# Groundwater Application Review Summary Form

Application # G- 18913 (Re-review)

TO: Water Rights Section Date 07/09/2020
FROM: Groundwater Section Phillip I. Marcy Reviewer's Name
SUBJECT: Application G- 18913 Supersedes review of 04/28/2020 Date of Review(s)

A. GENERAL INFORMATION: Applicant's Name: Zahary A. Reutov County: Clackamas

Water-Level Trends in Nearby Wells

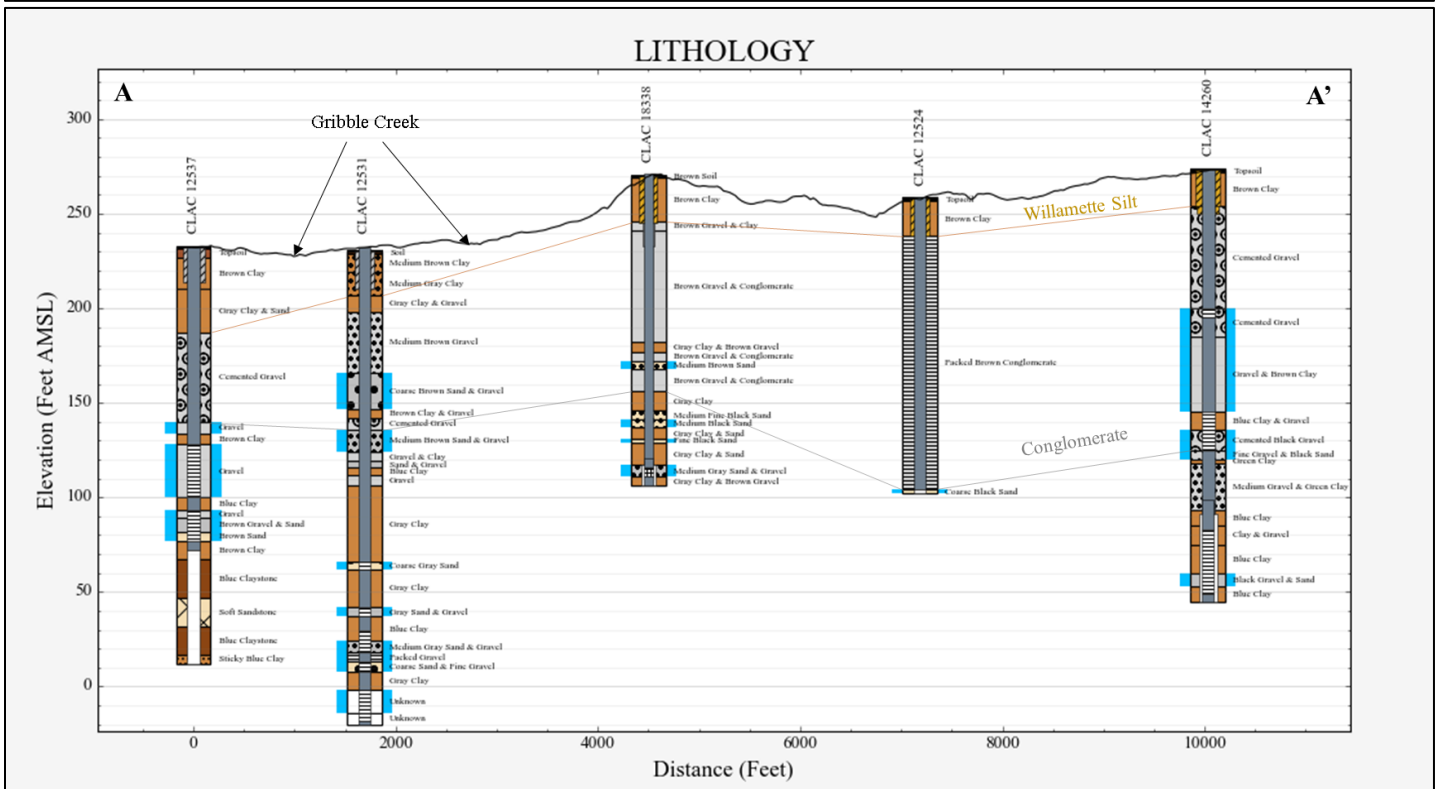
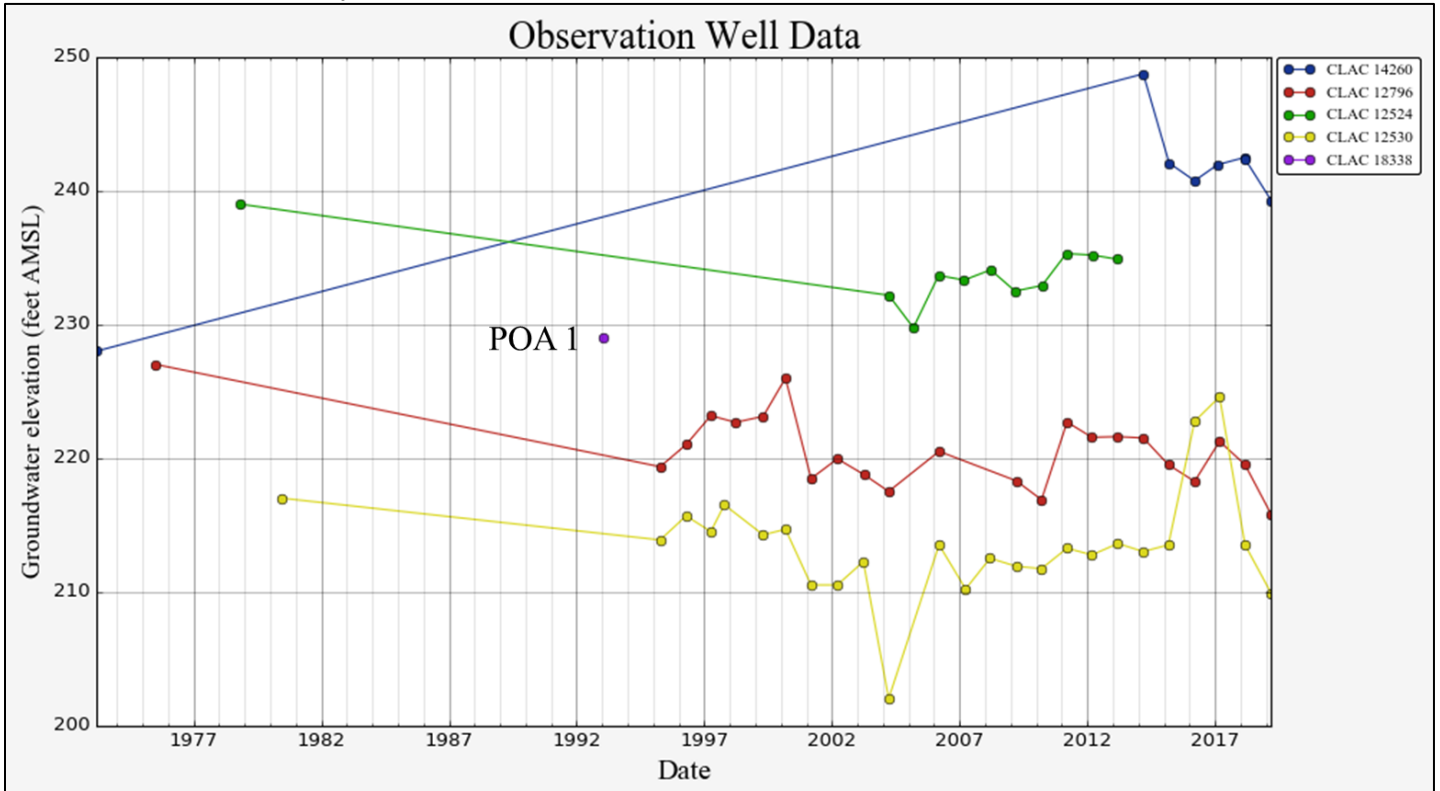
B3. **Groundwater availability remarks:** Water levels in nearby alluvial wells are relatively stable (see attached hydrograph), with no discernable decline trend in the area. All wells displayed produce from sand and gravel lenses of the Willamette Aquifer (Gannett and Caldwell, 1998), and though open to varying depths, appear likely to be hydraulically connected and display elevation differences commensurate with gradients of local streams.

### Well Location Map

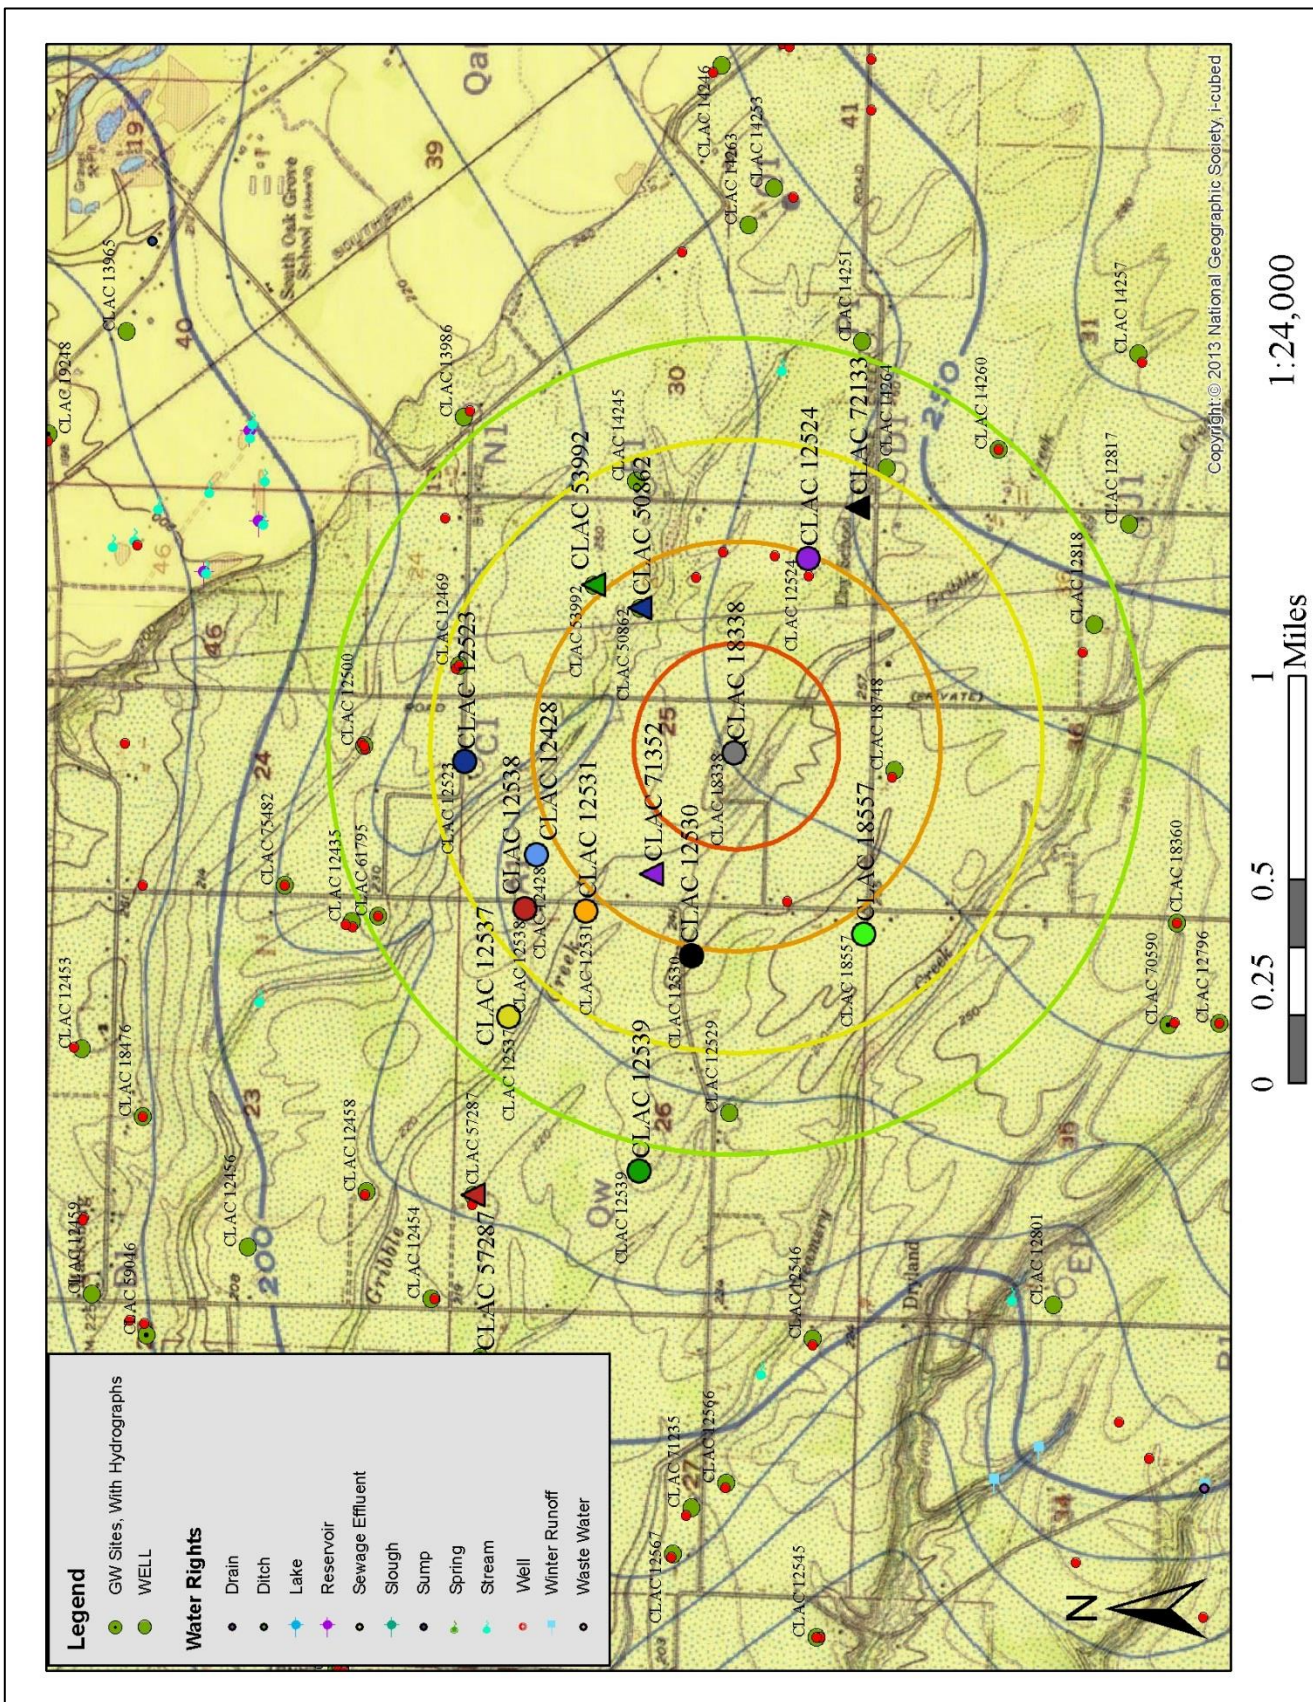
Water level contours from WSP 1997 (Hampton, 1972) are shown in blue, and are consistently lower than land surface elevations where they intersect drainages in the area surrounding the proposed POA wells. Colored symbols represent wells whose water level elevations are compared in the table below.

\*Gribble Creek streambed elevation measured perpendicular to hydraulic gradient from corresponding well  
 Compared above are available water level data from nearby wells, compared to the elevation of the streambed of Gribble Creek. Though inexact, a best estimate was made to obtain the streambed elevation at right angles to the slope of the hydraulic gradient. In some cases, wells are very close to the Gribble Creek Drainage, such as CLAC 12531 which is less than 100 feet away from the creek, and yet reports a groundwater elevation almost 30 feet lower than the nearby streambed elevation. CLAC 57287 is located greater than one mile downstream, and also reports groundwater well below the elevation of Gribble Creek.
